ECE/TRANS/WP.29/2009/123/Corr.1  
20 November 2009

Revision of the Consolidated Resolution on the Construction of Vehicles (R.E.3)

Corrigendum

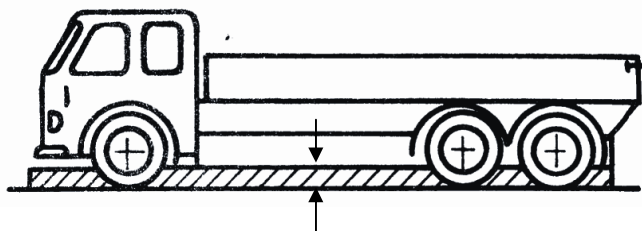
Page 12, chapter II, section G, paragraphs 2. and 3., correct to read:

(d) When measuring front and rear incidence angles and ramp angles, no account is taken of **underrun protective devices**.

3. Definitions and sketches of front and rear incidence angles, **ramp angle and ground clearance**.

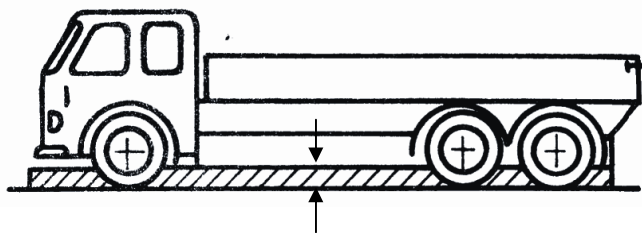
Page 12, chapter II, section G, paragraphs 2. and 3., correct to read:

(d) When measuring front and rear incidence angles and ramp angles, no account is taken of **underrun protective devices**.

3. Definitions and sketches of front and rear incidence angles, **ramp angle and ground clearance**.
